## REPORT TO CITY PLAN COMMISSION

**Item:** Preliminary/Final Plat/ Second Addition to Clearwater Creek

**TO:** Brad Schmidt  
**FROM:** Pete Neuberger / Ross Buetow  
**DATE:** June 16, 2014  
**RE:** Clearwater Creek 2<sup>nd</sup> Addn. Drainage Plan / Stormwater Management Plan Comments

DRAWING NO. S-2344  
SHEET NO. C1.0  
PROJECT NO. VISION RAEITY & DEV., LLC  
GRADING & SITE UTILITY PLAN  
FILE: V-014E-tp 10/11.dwg

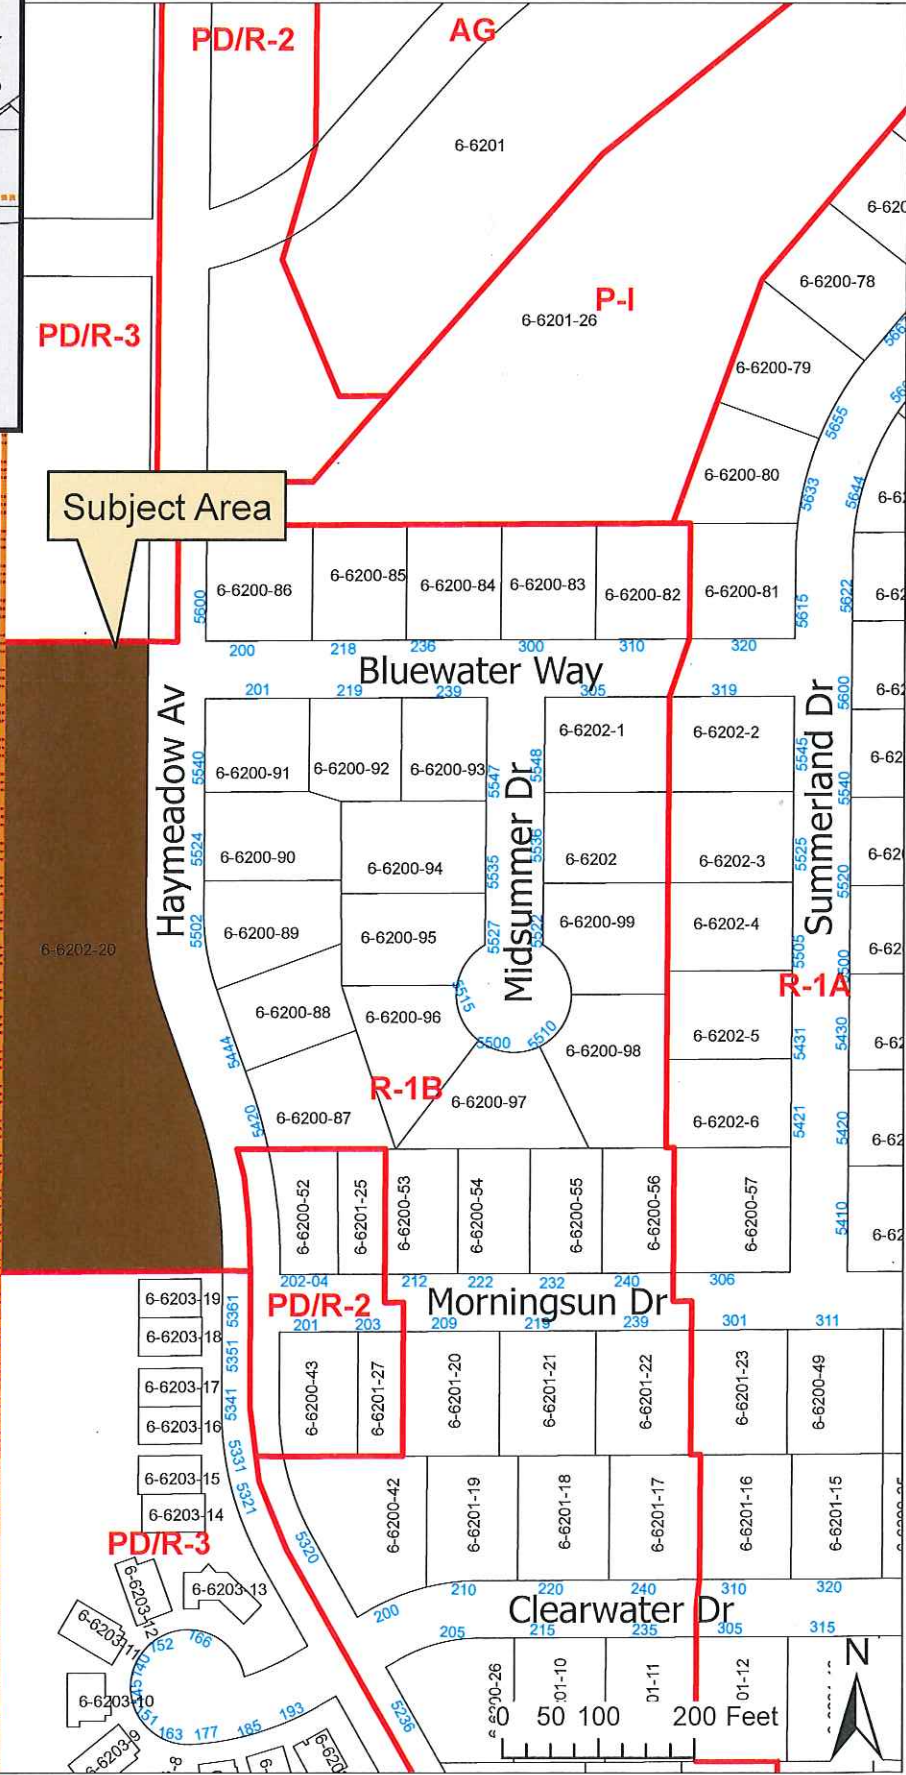
1. The Drainage Plan as submitted is labeled “Grading and Site Utility Plan”. The required Drainage Plan is a separate document from the Grading and Site Utility Plan and must show different information. Label the Drainage Plan as such.

2. Remove the sanitary manhole schedule and sanitary sewer information
3. Remove the note that reads “Exact grades...”
4. Remove the note that reads “Developers/Owners have...”

5. Provide a note as follows: “The roof drains and sump discharge of each parcel shall be directed to the rear yard of each parcel. Direct connection to the rear yard public storm sewer is allowed. A City of Appleton plumbing permit is required for each storm sewer connection.

6. Provide the following information with corresponding symbol legend:
  - a. Storm Sewer
  - b. Storm Manhole
  - c. Storm Inlet/Yard Drain
  - d. Proposed Spot Elevations (required at all lot corners and lot line grade breaks)

- e. Existing Spot elevations (required at west plat line lot corners/lot lines)
  - f. Drainage direction arrows on lot lines and easement swales.
  - g. Existing contours

7. Provide P.E. stamp, signature, and date.
8. Provide North Arrow and Graphical Scale.
9. Provide benchmark(s) on City datum.
10. Provide Location Map.
11. Provide lot line dimensions along all lot lines of each lot.

12. Provide a note that states: “This Drainage Plan indicates drainage along lot lines and major drainage swales. The owner of each lot is responsible for the design of interior lot drainage not specified on this plan so as to deliver interior stormwater runoff to the easements and/or lot lines as indicated in this Drainage Plan.

13. Provide a note that states “Maintenance of drainage swales and property line drainage, including vegetation maintenance, is the responsibility of the corresponding property owner. Upon failure of a property owner to maintain such facilities so as to ensure adequate drainage as intended by this Drainage Plan, the City of Appleton retains the right to perform necessary maintenance and assess any associated costs back to the responsible property owner.”

14. For proposed spot grades, show only spot grades along lot lines and in easements for major drainage swales.
  - a. Do not show proposed contours/spot elevations for interior site drainage

- b. Do not show building foundations, driveways, or Top of Foundation elevations.

15. Provide spot elevations and drainage direction arrows for the major drainage swale that approximately follows the public storm sewer alignments immediately east of the rear yard landscape berm.

16. Provide drainage direction arrows along all lot lines and swales.
17. Provide a berm cross-section detail. Since the berm (according to the Clearwater Creek 1<sup>st</sup> addition drainage plan is 35.5' wide, the 40' wide storm sewer and landscape easement does not provide enough room to maintain the storm sewer. Label the adjacent 12' utility easement also as "Storm Sewer & Drainage" easement. Show this on the Plat as well.

18. Label the 20' Storm Sewer Easement along the north lot line of Lot 121 also as "Drainage Easement". Show this on the Plat as well.
19. Use different line types to differentiate easement boundaries from lot boundaries.

20. Provide spot grades along the north lot line of Lot 121 and any spot grades/drainage direction arrows as may be needed to provide for adequate collection/conveyance of stormwater runoff so as to prevent runoff from entering the parcel north of Lot 121.

21. Provide Rim elevations of all storm manholes/inlets/yard drains outside street right-of-way.
22. Provide spot elevations along the west plat line, indicating to match existing grades.
